DCP/NRC1486
Project 711

SUBJECT: Transmittal of Westinghouse Responses to Requests for Additional
Information (RAIs) for AP1000 Pre-Certification Review

AP1000 PRE-CERTIFICATION REVIEW

REQUEST FOR ADDITIONAL INFORMATION

Figure 1: PRHR Component Test Results (Ref. 1)

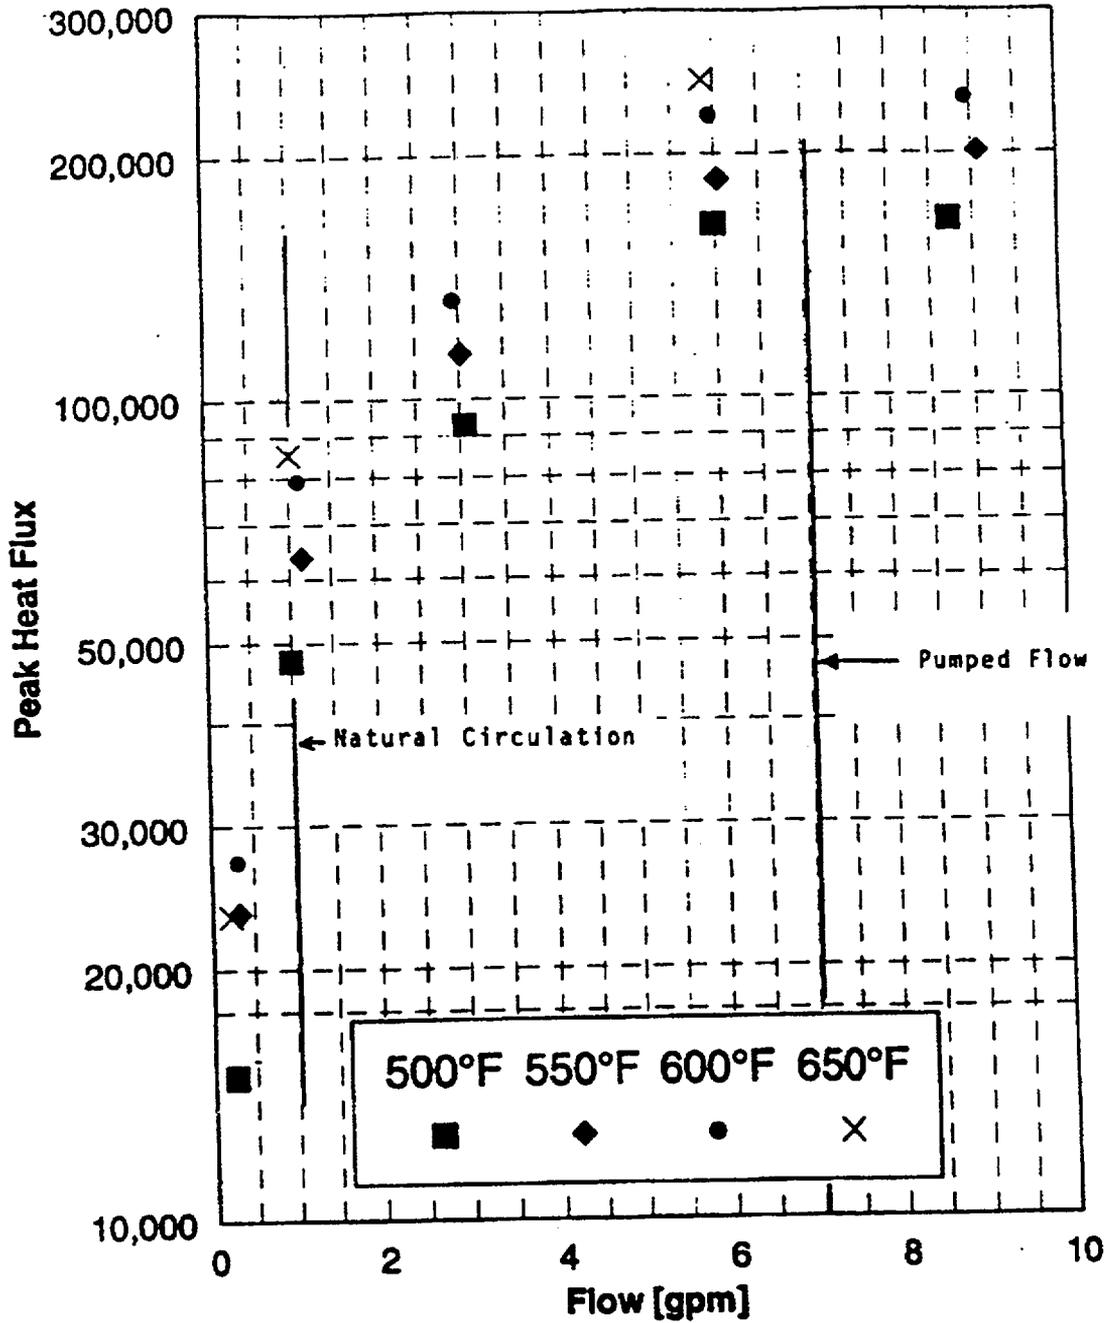
The PRHR for AP1000 will be 22% larger than for AP600, but the average heat flux is expected to be 42% greater. Justify that the expected heat flux is bounded by test conditions. Justify that the heat transfer correlations in NOTRUMP and LOFTRAN codes are adequate to model the greater heat flux.

Figure 1 from Reference 1 shows the range of heat flux conditions that were covered by the AP600 PRHR heat exchanger test. The tests covered heat fluxes as high as 250,000 BTU/hr-ft². In LOFTRAN, the PRHR heat transfer correlation is applied, unless the calculated heat flux is greater than Critical Heat Flux (CHF). The correlation is therefore applied up to CHF. Figure 2 from Reference 2 shows the calculated heat flux for the AP600 and AP1000 PRHR heat exchangers under both natural circulation, and forced flow conditions. For all cases, the calculated heat flux, as predicted using the PRHR correlation, is much lower than

Figure P33-1

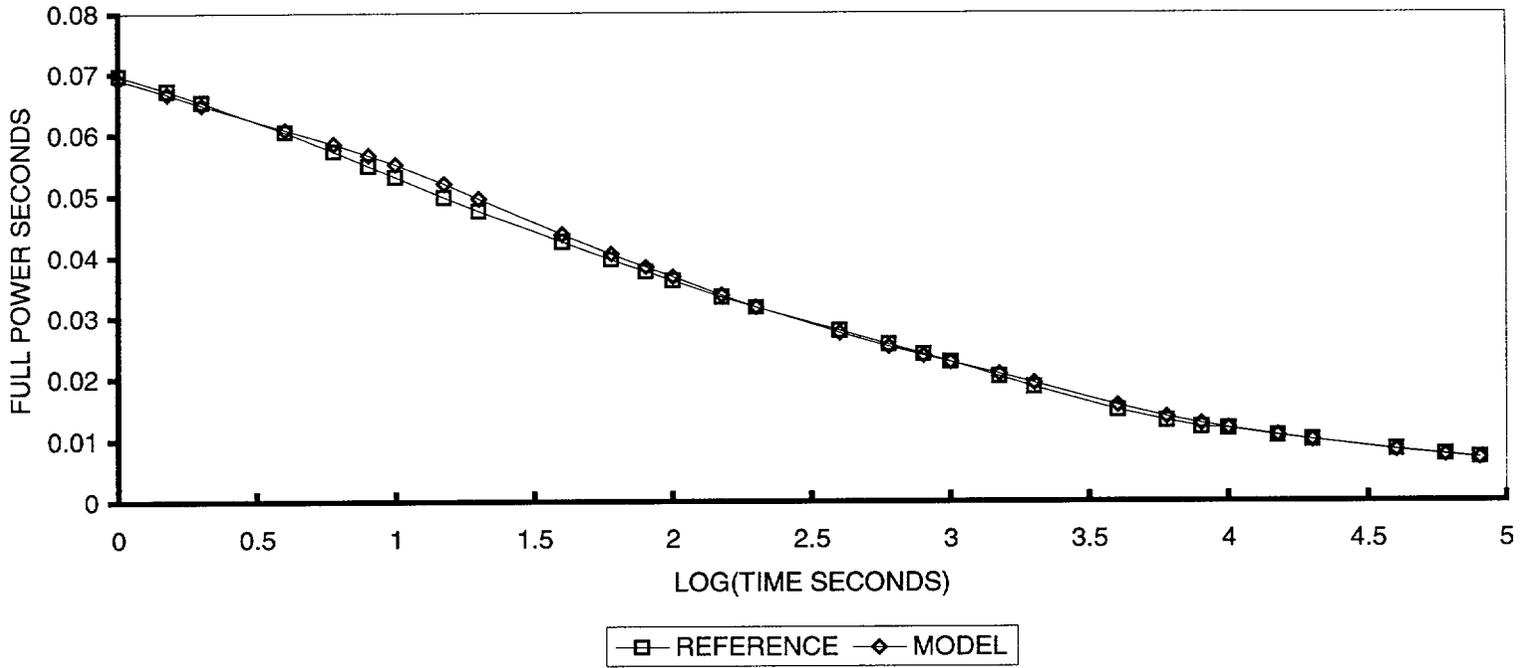
Describe the decay heat model that will be used in LOFTRAN for AP1000 analysis. Justify that this model is conservative for transient and accident analysis. Provide comparisons of the model with the American Nuclear Society Standard 5.1.

The generic decay heat curves developed above bound Westinghouse standard and optimized fuel design with 15x15, 16x16, 17x17 fuel assembly configurations. The attached figures show a comparison plot of LOFTRAN calculated decay heat curve using nine exponential terms against the bounding generic ANSI/ANS-5.1-1979 decay heat model. The exponential terms may be input depending upon conservatism desired in the analyses or time duration of the event analyzed.

Figure P50-1: ADS-4 Steam Flow – 2inch Cold Leg Break

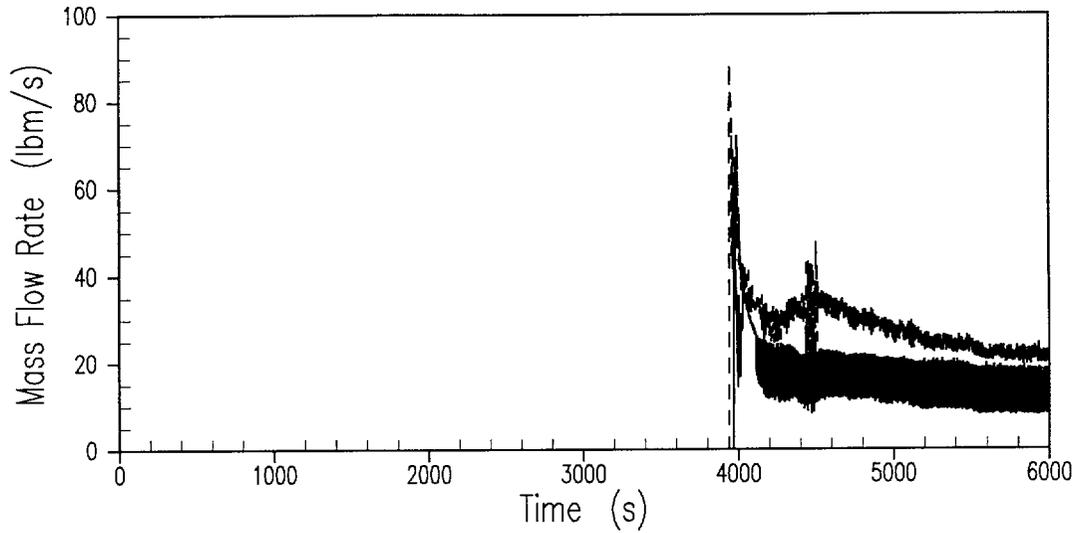
Provide the Automatic Depressurization System Stage 4 (ADS-4) vapor phase flow rate for the 2-inch cold leg break to accompany Figure 3.3.1.4-31 of WCAP-15612, and a figure or table providing the water level in the hot legs for this transient. Also provide the core exit vapor flow rate.

Please see the attached figures and table. The results provided correspond to the analysis of 2-inch cold leg break presented in WCAP-15612, "AP1000 Plant Description and Analysis Report."

Note that ADS4-2 is atop Hot Leg 1, and ADS4-1 is atop Hot Leg 2 in the legends of the plots.

Figure P51-1: ADS-4 Steam Flow – Double-ended DVI Break

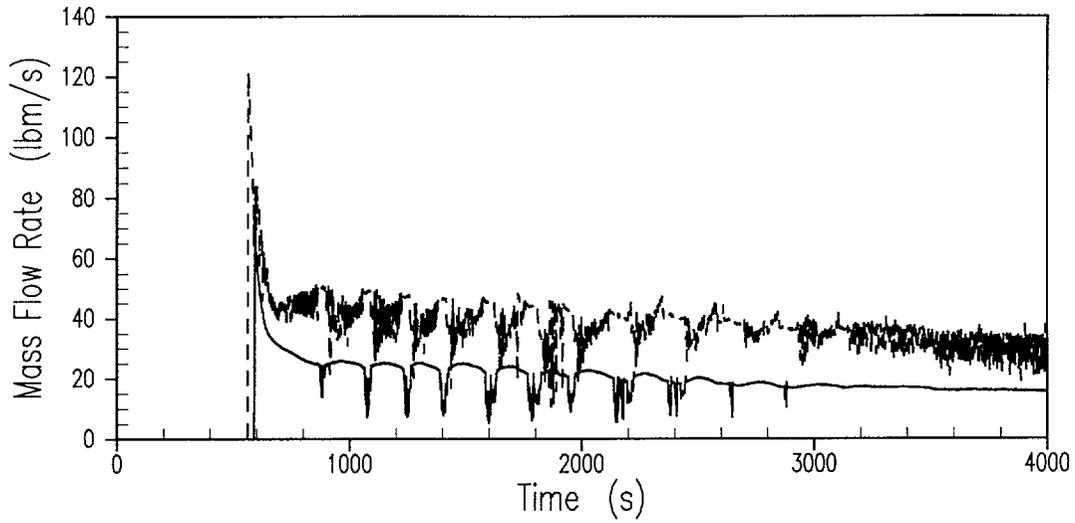
Provide the expected ADS-4 vapor phase flow rate for the DEDVI (double-ended direct vessel injection line) break, and the water level in the hot legs for this transient.

Please see the attached figures and table. The results provided correspond to the analysis of DEDVI presented in WCAP-15612, "AP1000 Plant Description and Analysis Report."

Note that ADS4-2 is atop Hot Leg 1, and ADS4-1 is atop Hot Leg 2 in the legends of the plots.

Figure P53-1: ADS-4 Liquid Flow – DEDVI Break

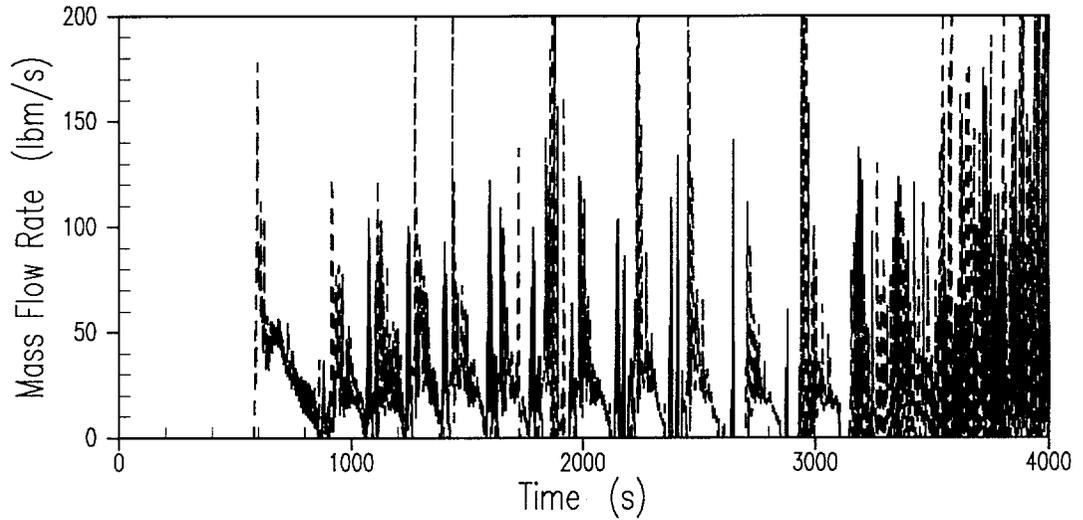
Which represents the ratio of the vessel liquid inflow and outflow from the CMT and pressurizer and the flow out the ADS-4. Provide flows to determine $(W_l)_0$ and $(W_{ADS4})_0$ for the DEDVI line break

- (ii) The requested flow rates are quantities are shown in the attached figures.
